# A review of the HumeLink Project Assessment Conclusions Report

VEPC WP2109  
September 2021

Bruce Mountain, Ted Woodley  
& Hugh Outhred

**Figure 2 The options presented geographically, showing individual circuits**

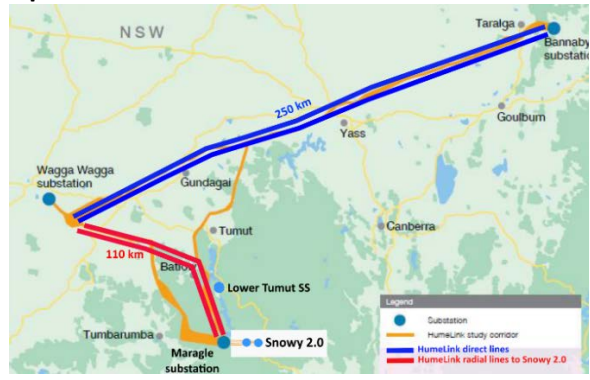
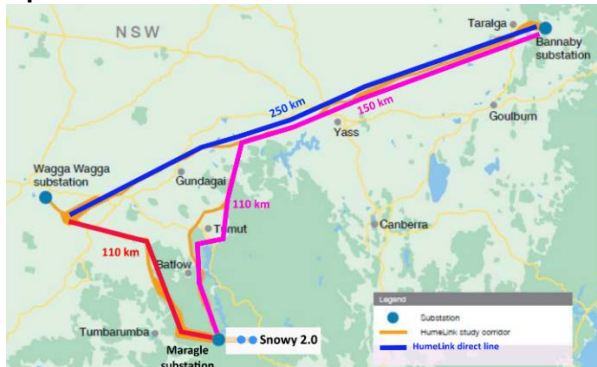
The PACR is quite confusing on the route for Option 3C, so Figure 2 presents it in two forms – 3C-1 reflects the schematic representation in Figure 1, whilst 3C represents what is thought to be the physical representation. The three colours represent the three legs of the HumeLink 'triangle'.

Figure 2 also introduces Options 2L and 3L, moving the Snowy 2.0 connection point to the existing Lower Tumut Switching Station (LTSS), as recommended in this paper, rather than the proposed new substation at Maragle.

However, there is confusion on the physical construction of Option 3C with double-circuit lines in light of the schematic representation in Figure 1 of a triangular arrangement. This paper assumes what is proposed is reflected in Figure 2, showing a Y arrangement, made up of double-circuit lines.

**Figure 4 Estimated net benefits weighted, excluding competition benefits, (PACR Figure 26)**

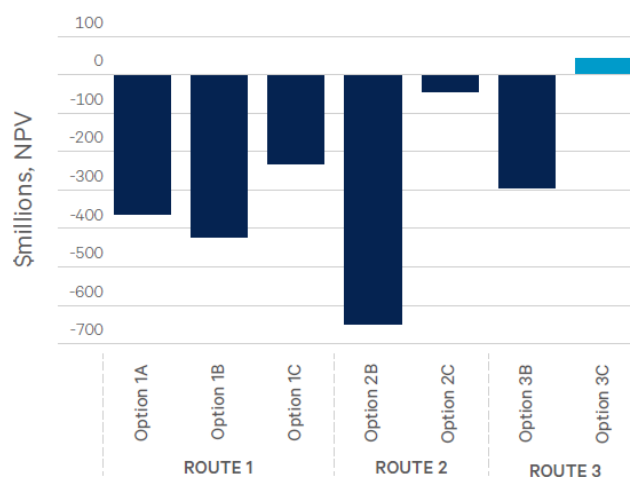
In the first stage, before accounting for competition benefits, only Option 3C had a positive net benefit of just \$39m. Option 2C is next with minus \$44m and then Option 1C with minus \$220m (Figure 4).

The PACR eliminated all but the top two of the seven credible options before calculating the competition benefits in the second stage, which resulted in Option 3C having a net market benefit of \$491m and Option 2C of \$400m.

Figure 5 AEMO 2021 Transmission Cost Report (information from TransGrid)

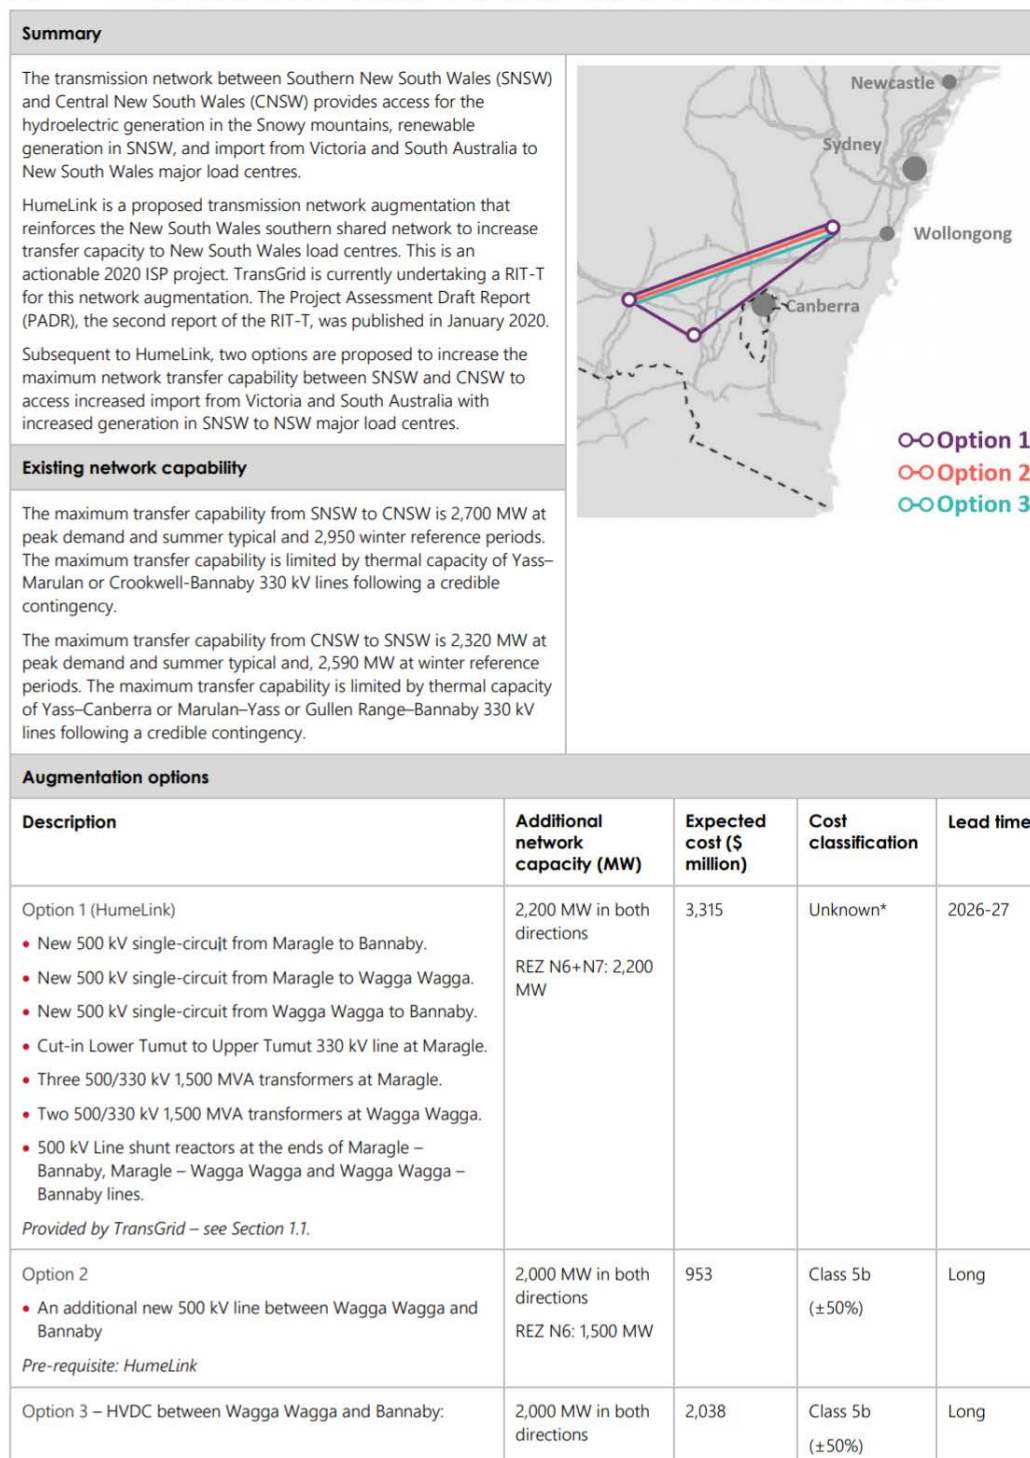
To add to the confusion, the [AEMO Transmission Cost Report, Aug 2021](#) was issued after the PACR indicating three single-circuit 500 kV lines between Bannaby, Wagga Wagga and Maragle at a cost of \$3,315m, based on information provided by TransGrid (Figure 5).

The PACR Option 3C schematic in the AEMO report (identified there as Option 1) also repeats the confusing PACR triangular routing schematic in Figure 1.

It is also noted there is a 370 MW anomaly between the PACR estimate of HumeLink’s capacity of 2,570 MW and the information provided by TransGrid to AEMO of 2,200 MW (Figure 5). It is assumed that the PACR estimate is the correct one.

Figure 7 Alternative underground routes from Snowy 2.0 to Maragle and LTSS

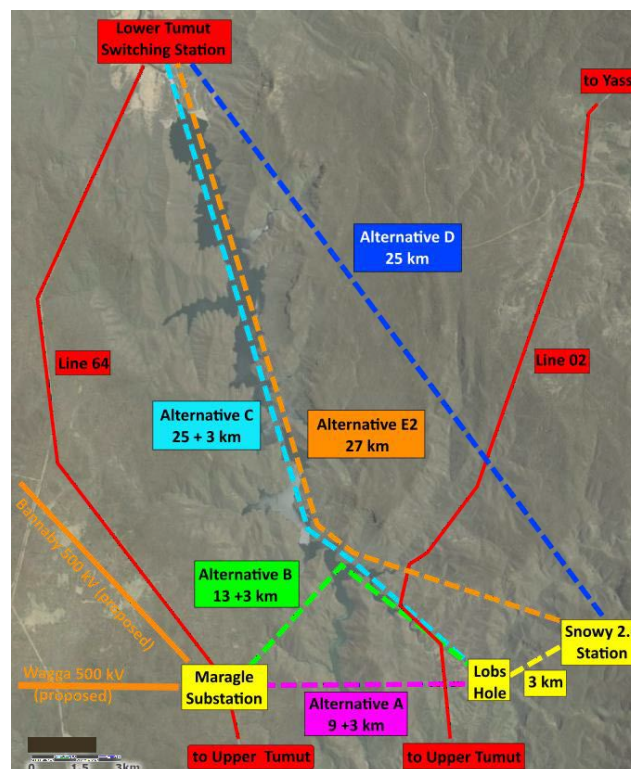
Figure 7, extracted from the EIS Submission, shows alternate underground routes from Snowy 2.0 to Maragle and LTSS. The most promising route to LTSS is likely to be Alternative D, entailing a 25 km tunnel. Alternative C involves submarine cables down Talbingo Reservoir.

**Figure 10 Connecting to LTSS rather than Maragle (Option 2L)**

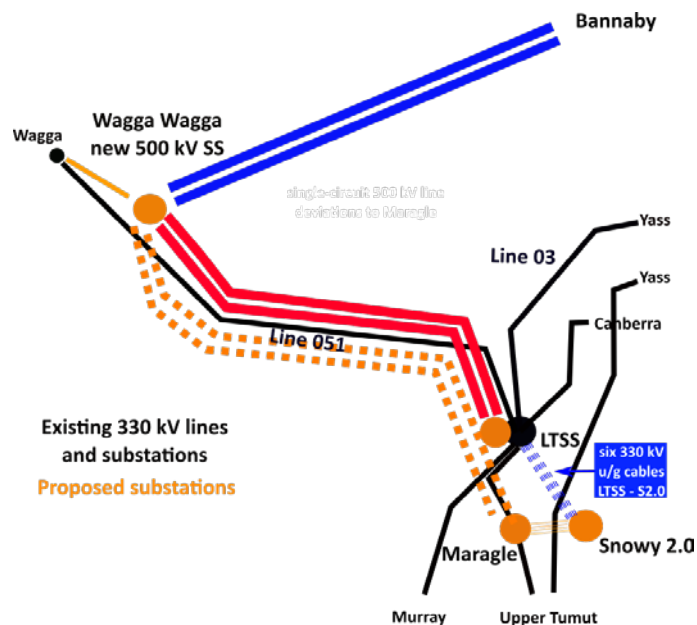
Figure 10 shows the LTSS hub, with the five existing 330 kV connections, to Murray, Upper Tumut, Canberra, Yass and Wagga Wagga, and the two 500 kV HumeLink connections for Option 2L.

The existing Line 051 could be ‘replaced’ with a 500 kV double-circuit line for its full length to the new Wagga Wagga 500 kV substation, as could Line 03 to Yass for Option 3L (see later).

Figure 11 Option 3LX

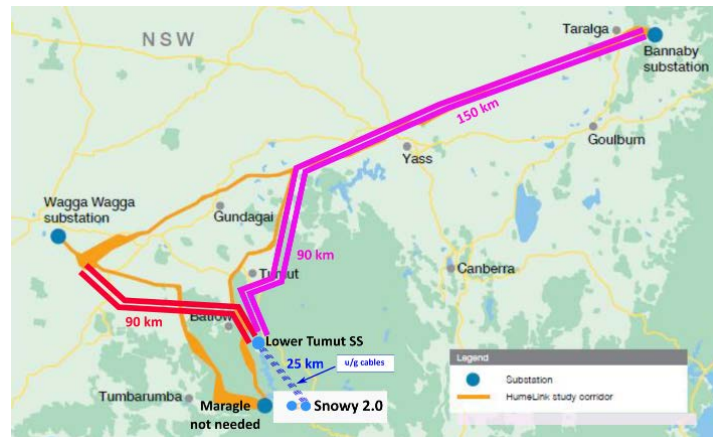
This paper suggests consideration of another option which is a variation of Option 3L, termed 3LX (Figure 11).

Figure 12 Southern NSW Network (TransGrid 2021 Planning Report Fig 2.16)

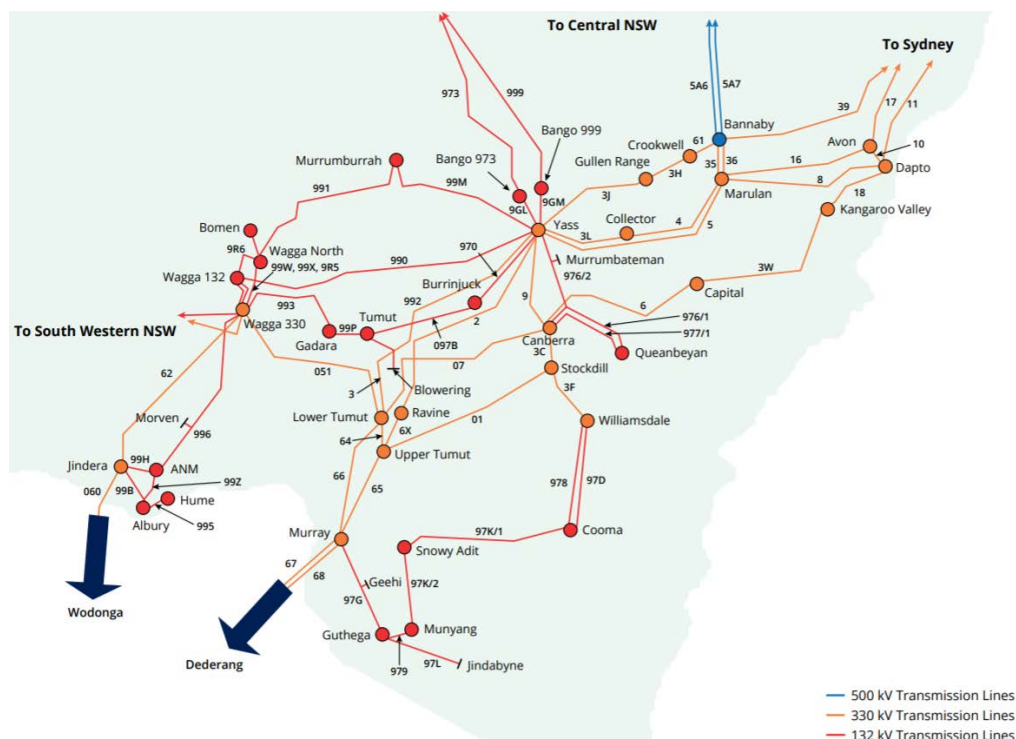
Figure 12 shows the southern NSW network. Consideration should be given to using the easements for the 330 kV lines from LTSS to Wagga Wagga (Line 051), from LTSS to Yass (Line 03), and from Yass to Bannaby (direct or via Marulan).

Figure 3: Forecast cumulative gross market benefit<sup>31,32</sup> for Option 3C under the Central scenario (excluding competition benefits), millions real June 2019 dollars discounted to June 2021 dollars

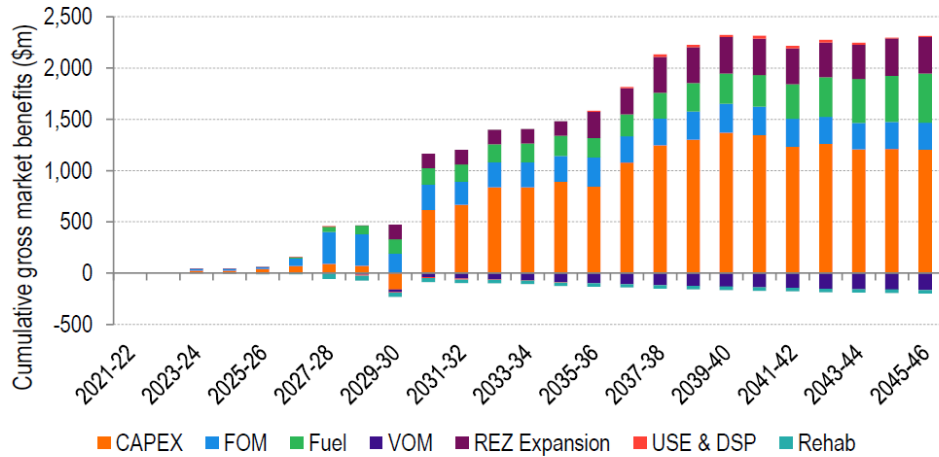
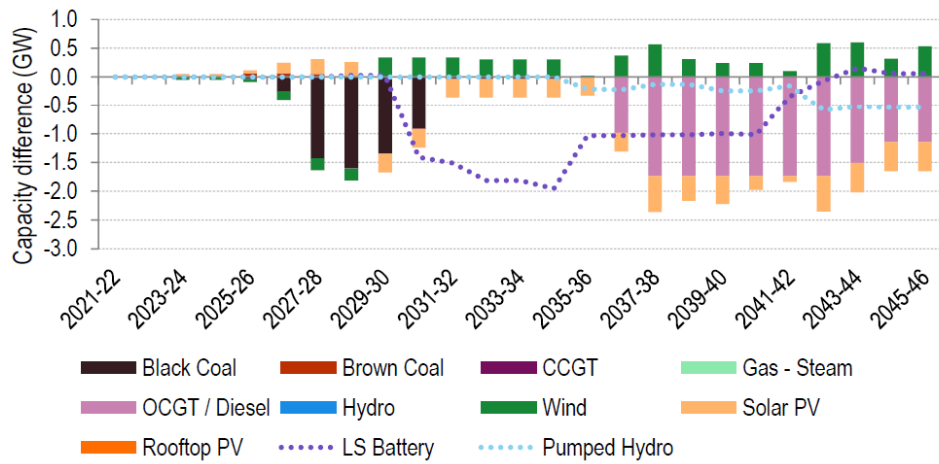
Figures 3 & 4 show cumulative benefits for Option 3C and capacity differences compared to the base case for the Central Scenario. From Figure 3, most of the market benefits are expected to come from displaced Capex. From Figure 4, Option 3C is credited with bringing forward black coal retirements by a few years, deferring LS Battery investment for many

<p>years and, from the late 2030's, displacing OCGT/diesel and preferencing wind investment compared to large PV investment. The underlying assumption seems to be that Snowy 2.0 would be able to capture the benefits by pumping when spot prices are low due to high-penetration wind &amp; PV.</p> <p>However, it is likely that wind and PV developers would be increasingly likely to co-locate battery storage to retain most of the benefits of low-value wind or PV generation. Owners of rooftop PV and EVs are likely to adopt the same strategy. EV's and domestic storage are mentioned on page 49 with respect to preparing the hourly demand forecast but are not treated as active storage devices. Hydrogen is not mentioned. Likewise, it is implausible that Snowy 2.0 will displace nearly 2 GW of OCGT/Diesel in the 2040's as the latter is very unlikely to be built rather than other options with additional benefits that Snowy 2.0 can't provide.</p> <p>Note that the difference between Option 3C and the Base case is due to the change in operation of Snowy 2.0 between the two cases. As discussed with respect to pages 29-30, EY states that, for the Central Scenario, Snowy 2.0 is projected to generate at 15-20% capacity factor in the Base case, compared to ~25% capacity factor in the Option 3C case. Thus, all the effects shown in Figure 4 are due to Snowy 2.0 operation increasing by around 6.5% (see below).</p> <p>Figure 5 shows the change in generation annual energy between the Option 3C case and the Base case for the Central Scenario. It shows wind displacing large PV, brown coal displacing black coal and Pumped Hydro displacing batteries. Pumped Hydro generation is expected to increase by more than 1 TWh/yr (say 120 MW average or ~6% capacity factor for Snowy 2.0), while battery generation reduces by a larger amount.</p>

Figure 21: Annual capacity factor for Snowy 2.0 generator and pump for the Base case in all scenarios

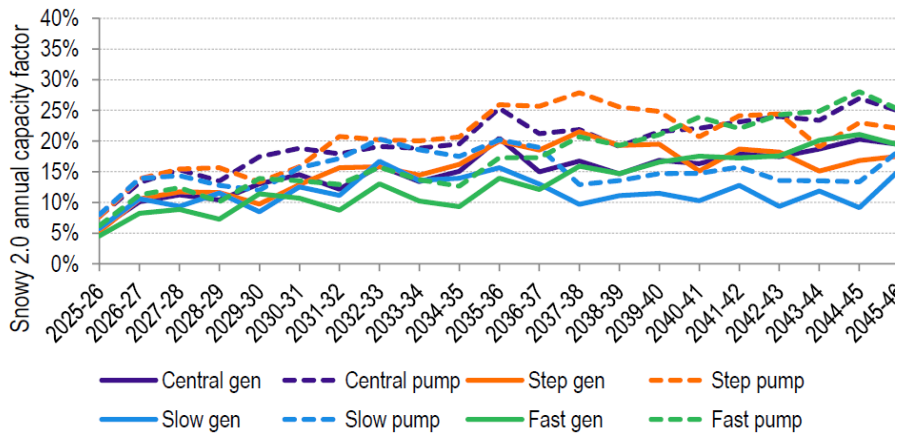
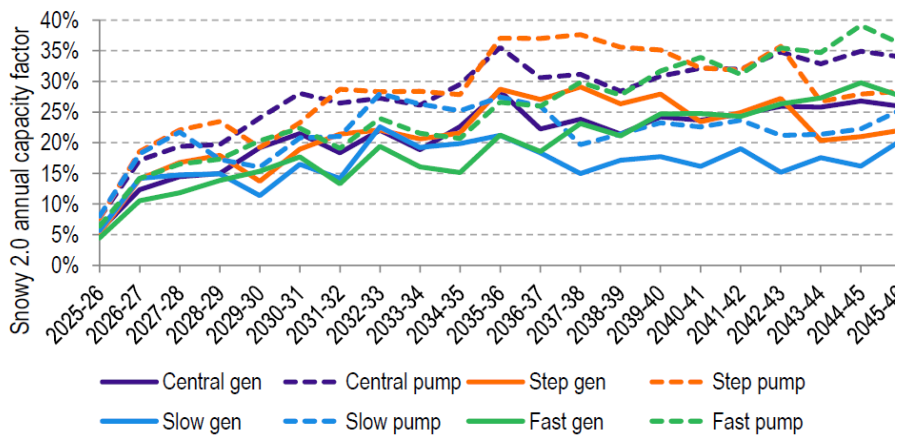
29-30	<p>EY Figures 21 &amp; 22 compare Snowy 2.0 operation (generation &amp; pumping) for all scenarios in the Base Case configuration and the HumeLink Option 3C augmentation configuration. Figure 21 shows that the EY model predicts that, in the Base Case configuration, Snowy 2.0 would operate without HumeLink, reaching highest capacity factors of 27% pumping and 20% generation in the Central Scenario. Note that MJA estimated Snowy 2.0's capacity factor to be ~22% (MJA Figure 30, p 82). Pumping would not compete with existing Snowy generation. If existing Snowy generation was constrained by inflow constraints, upper reservoir issues or downstream release constraints, Snowy 2.0 pumping, if sufficiently cheap, would allow Snowy Hydro to obtain more commercial value from Snowy 2.0 generation at other times. However, whether that would be profitable is another matter. In the HumeLink Option 3C augmentation configuration, EY expects Snowy 2.0 to reach highest capacity factors of 35% pumping and 27% generation in the Central Scenario. Note that Figures 21 &amp; 22 indicate that EY simulated round trip losses for Snowy 2.0 at about 25-27%.</p>

30	<p><i>"Snowy 2.0 operation increases on average around 6.5% in the Central, Step and Fast Change scenarios, and 5.3% in Slow Change."</i> The additional 6.5% capacity factor is effectively the EY estimate of additional operational activity for Snowy 2.0 due to HumeLink.</p>
